Project Name:	Mixed-Use Development		
Project ID:	2015-139		
Address:	101 York Street	CBLs:	40-C-3, 4, 5, 9, 18, 22, 25, 33
Applicant:	101 York Street, LLC		
Planner:	Nell Donaldson

101 York Street Amended Subdivision Plat  
 101 York Street  
 Level III Site Plan and Subdivision Review  
 2017-084  
 101 York Street, LLC

Submitted to: Portland Planning Board	Prepared by: Nell Donaldson, Planner
Date: June 15, 2017	CBLs: 40-C-5
Public Hearing Date: June 22, 2017	Project #: 2017-084

AMENDED SUBDIVISION PLAT

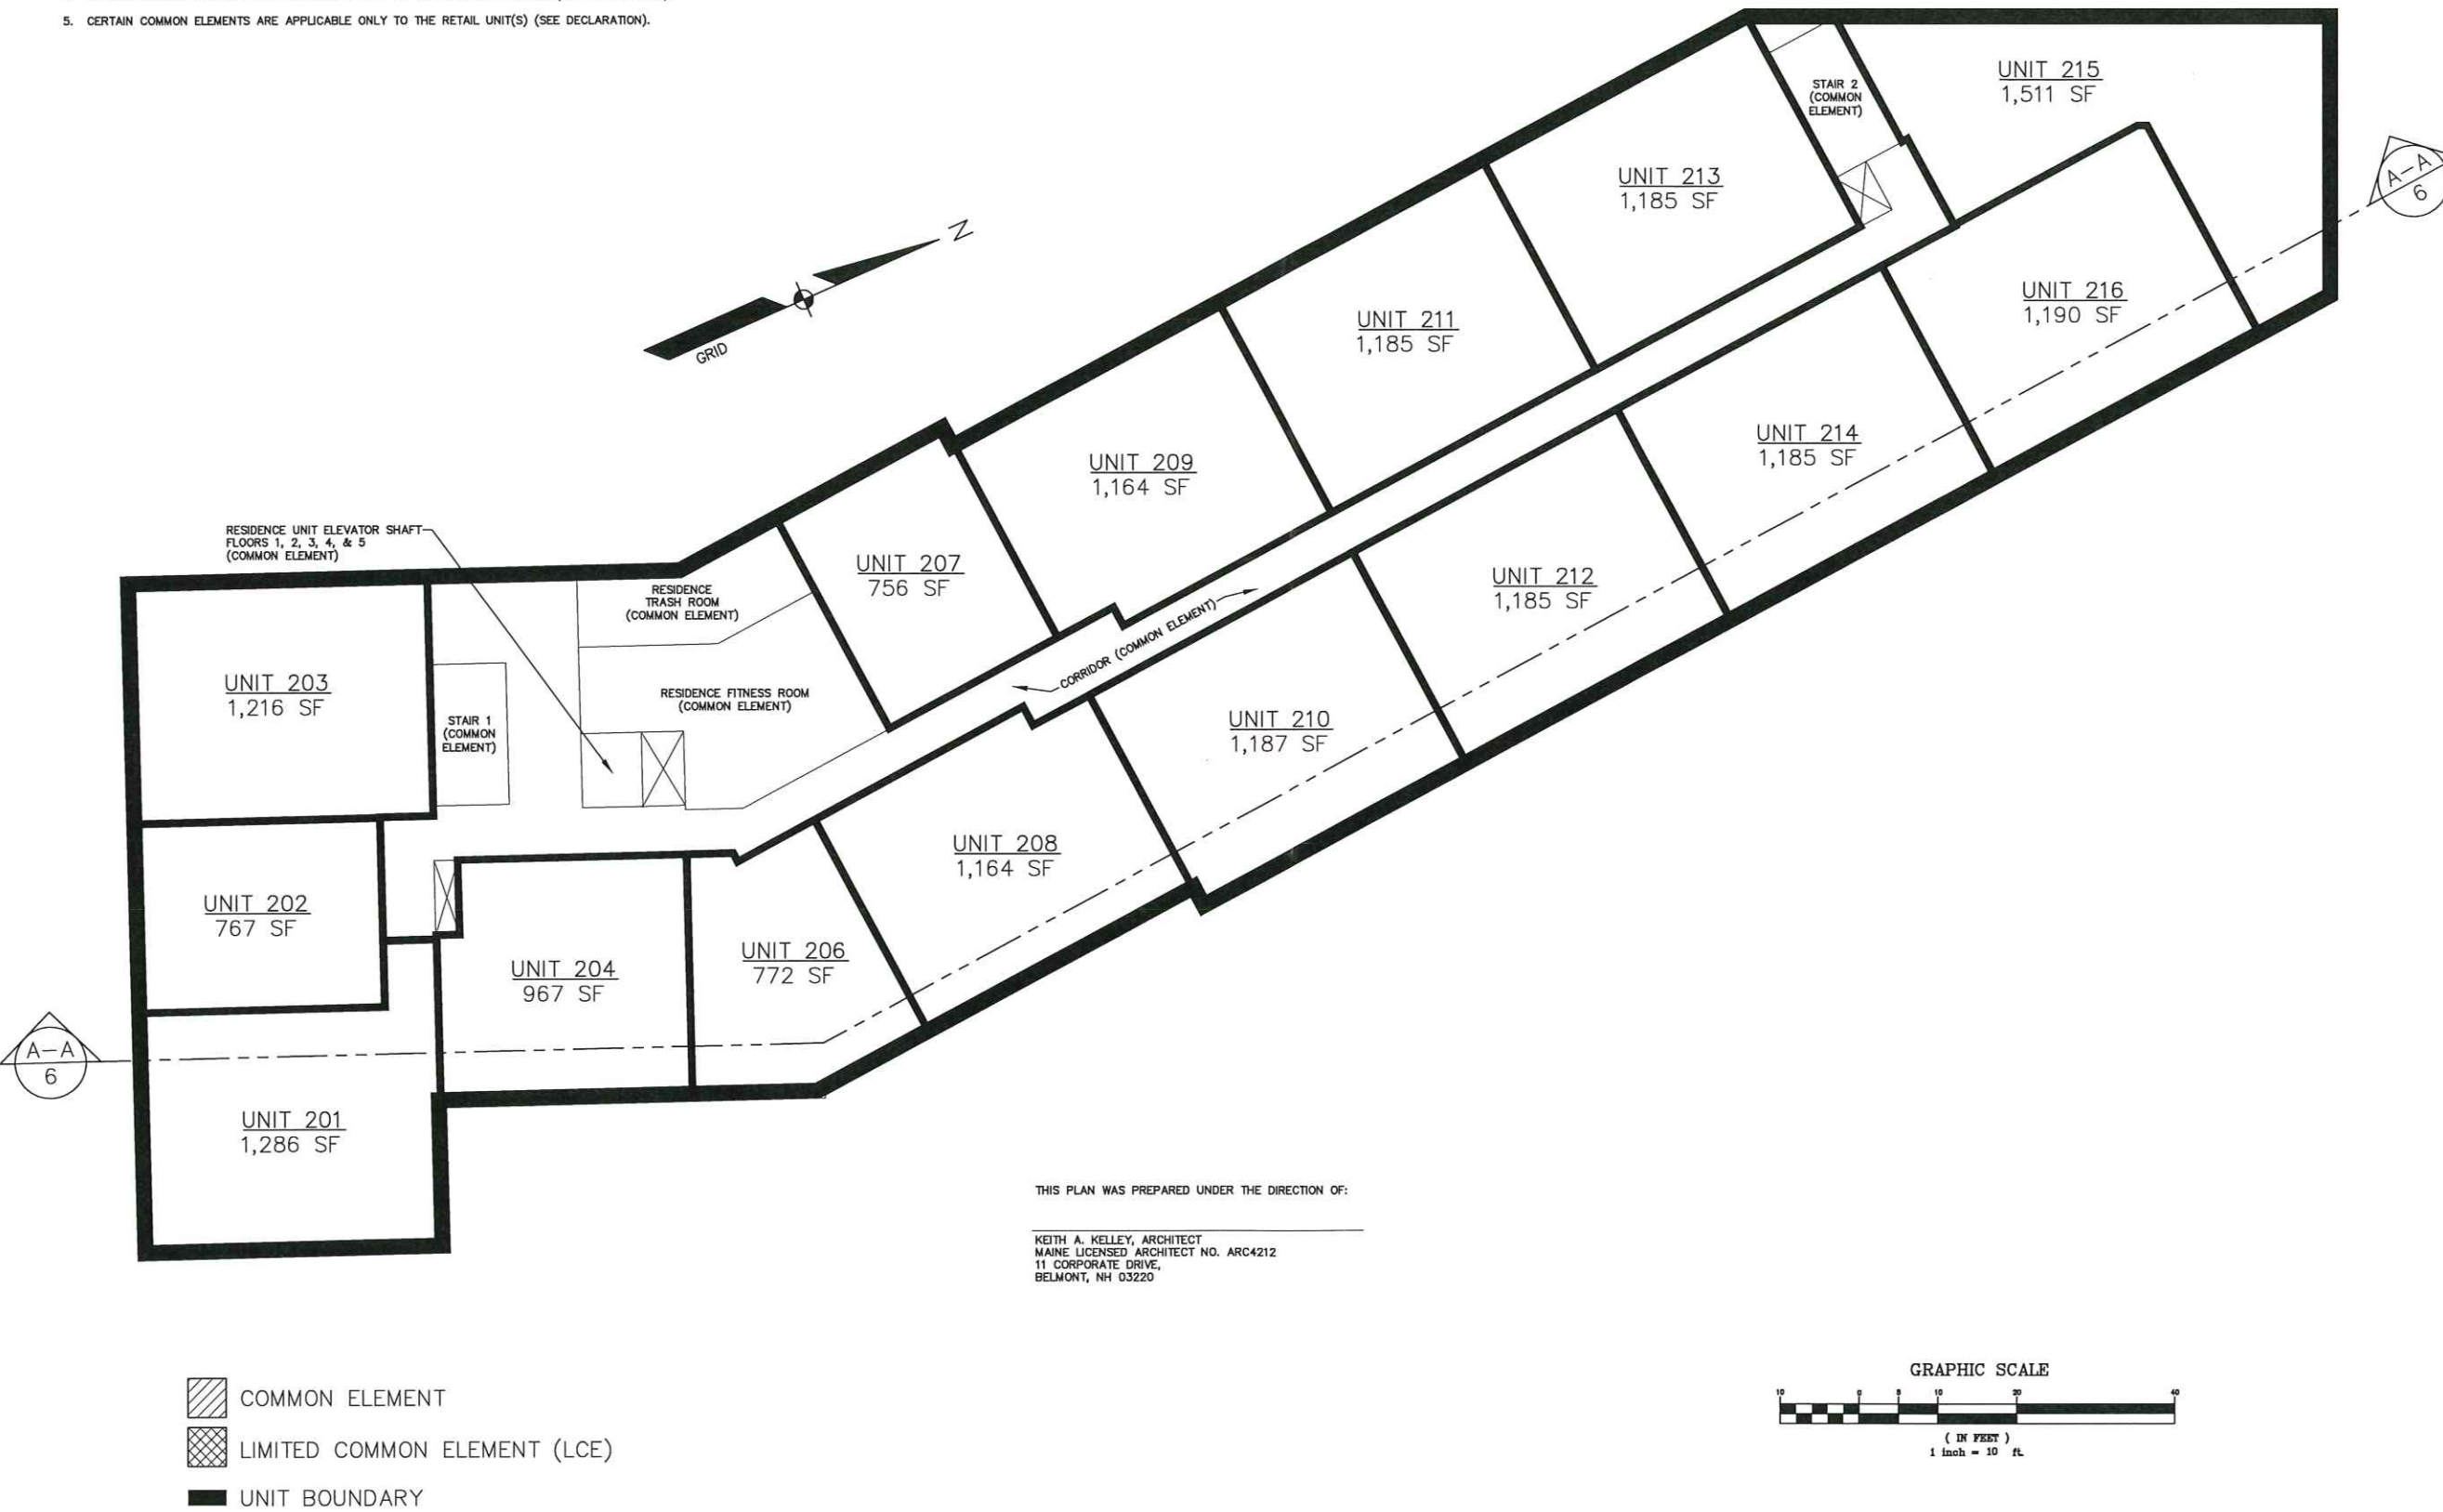
*Neither the Revised Division of Lots Plan nor the Amended Subdivision Plat show the four granite monuments to-be-set as per the approved Subdivision Plan. These need to be added to these plans and we need to make sure that they get set as part of the ongoing construction project;*

*One of the "new" boundary lines on the Amended Plat is labeled "75.48" feet. This line is shown as "79.78' feet on the Division of Lots Plan and in the proposed deed description. This label should be corrected;*

*I am a little confused by the way these two plans call off the Record Owners of the properties. The Title Block on the Amended Subdivision Plat says the record owner is 101 York Street LLC. The Title Block of the Revised Division of Lots Plan says the record owner is J. B. Brown & Sons. Although both plans do reference both record owners along with deed references and tax map-block-lot references in the plans' Notes, none of those labels appear in the plan view. Instead, the only labels are "New Lot A" and "New Lot B". I think it would be less confusing if either the New Lot designations were added to the Record Owner Notes or if the Record Owner info was added to the plan view;*

*The Surveyor's Certification includes the words "...with the exception of markers not set at all corners" on the Amended Subdivision Plat but it does not have the same exception listed on the Revised Division of Lots Plan. I think it belongs there as well.*

Final review of the revised plat, submitted to address these comments, and final review of all necessary easements and agreements have been suggested as conditions of approval.

Figure 5: Site plan, with proposed building shown in red

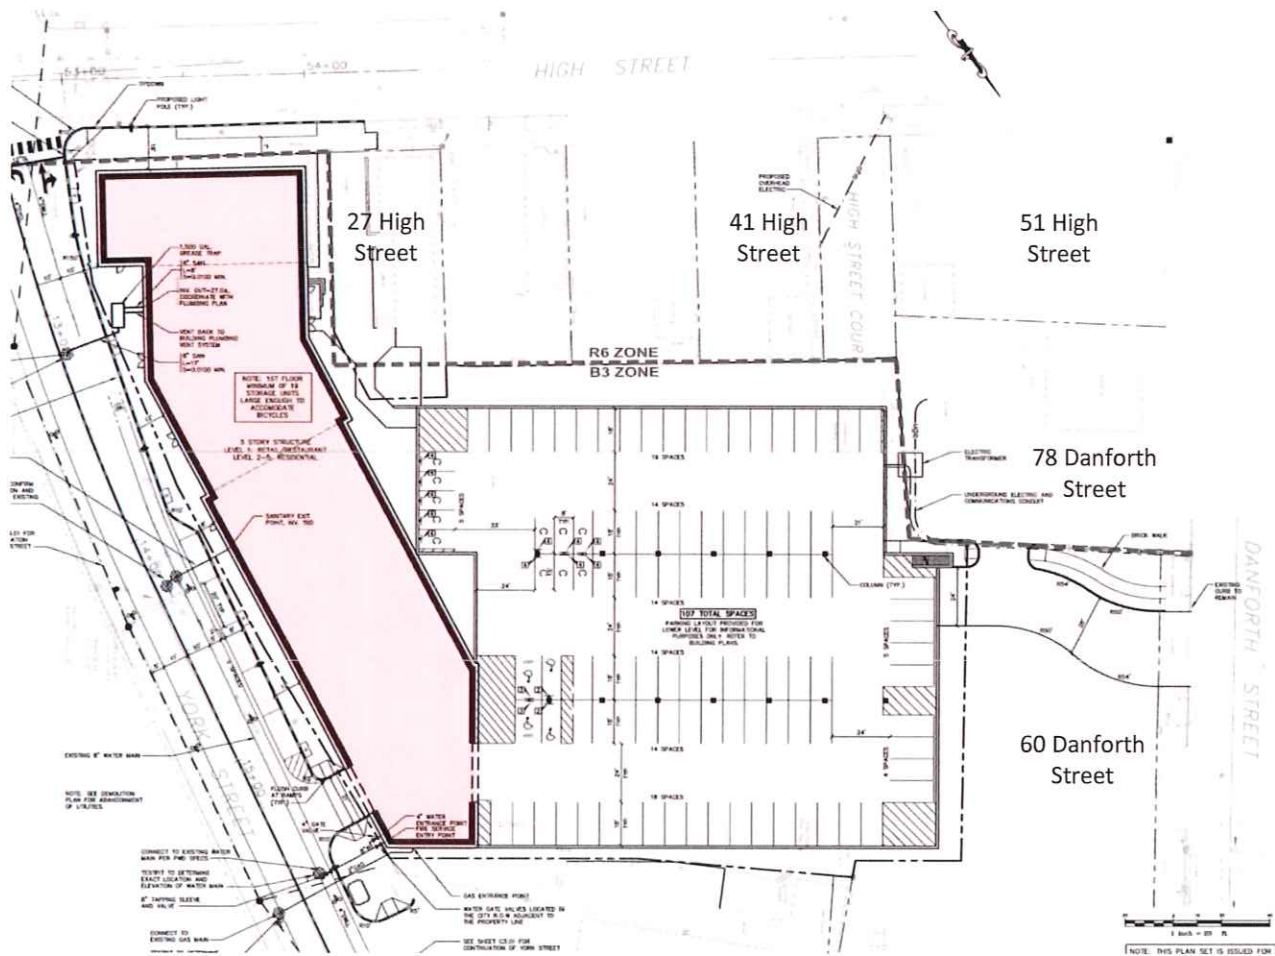
In the final plans, the building continues to exceed the B-3 zone's maximum front yard setback of five feet in several locations. The plans show the point of greatest building setback on the York Street frontage at just over 21 feet (*Figure 6*). In their preliminary submittal, the applicant argued that these setbacks are necessary because of the "unusual geometry of the right-of-way line along the frontage" (*Attachment G*). The applicant has also stated that the increased setbacks will "provide pleasant sidewalk widths while accommodating east-west bike lanes, east-west sidewalks and on-street parking" and provide an "opportunity to support open space amenities such as building entries, outdoor seating, street trees, bike racks, and municipal lighting" (*Attachment U*).

Figures 1 and 2: High Street façade, elevation shown at Planning Board hearing (left) and revised elevation (right)

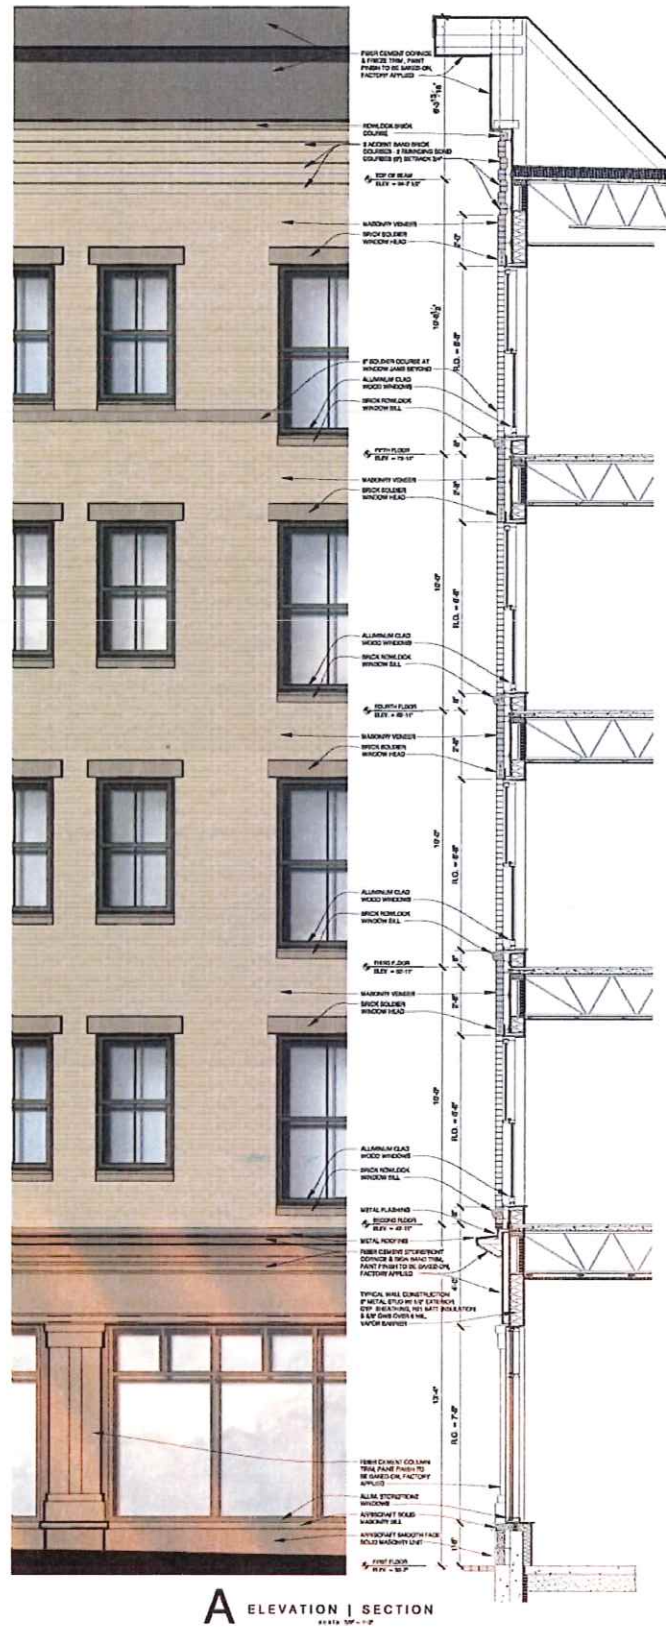
- *Blank facade:* The applicant has modified the design of the 50' span of blank façade on the High Street frontage to incorporate a stepped planter design (Figures 1 and 2). In the revised hardscape plan, this planter is depicted with a "decorative retaining wall" constructed of smooth face solid masonry units to match the storefront base to the south. Planting would continue to include Bosnian pine, black-eyed susan, sedum, switchgrass, viburnum, and Mountbatten juniper.
